**INITIAL ACKNOWLEDGMENT FAX SHEET OF RECEIPT OF DEFECT  
INFORMATION REPORT SUBMITTED UNDER 49 CFR PART 573**

Assigned Recall No. 99V-132 by the  
National Highway Traffic Safety Administration

Subject: Recall Campaign for Cam Chain Tensioner Adjuster on GSX-R750X and GSX-R600X

#### **Tensioner Adjuster:**

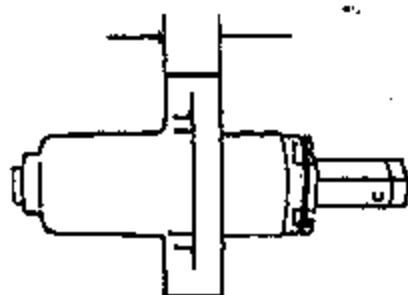
The rubber damper is newly added at the head of the push rod to absorb the force received from the tensioner and also to eliminate the abnormal noise from the cam chain.

The new tensioner adjuster can be identified from the original one by measuring the flange thickness of the tensioner adjuster body. (See the illustration below.)

**GSX-R750X:** The flange of the modified one is thicker by 2 mm than the original.

The thickness is changed from 14.5 mm to 16.5 mm.

**GSX-R600X:** The flange of the modified one is thicker by 5 mm than the original.

The thickness is changed from 14.5 mm to 19.5 mm.

**Cam Chain Guide No.2:**

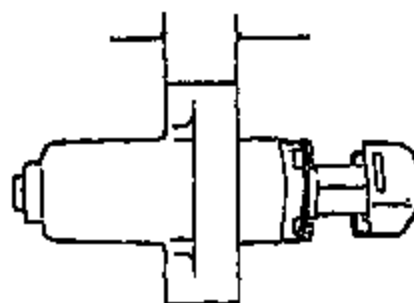
The rubber shape is redesigned to reduce the erratic movement of the cam chain.
